Access Compliance Report

Public Rights-of-Way

(Pedestrian Signals)

Intersection ID: N/A	Main Street:	Cross Street: N/A	Location: N/A
ADA ID: 261E79843622	Signal Type: Two Push Buttons-APS	Overall Compliance: No	Severity Score: BTN 1:N/A BTN 2: N/A No BTN: N/A
Codes/Mitigation Info/Possible Solution		Field Measurements/Component Compliance

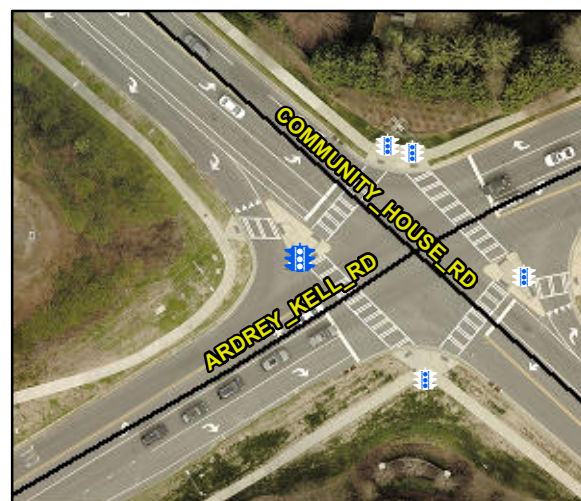
PROW/ADA: R404.2, R404.7.1, R404.7.2, ,
TMUTCD 4e.08, R404.3

Possible Solutions: Remove & Replace
Replace APS Button With New APS Button.
Provide Clear Space. Replace Signal Push
Button With APS Button on New Post.
Remove & Relocate Sign.
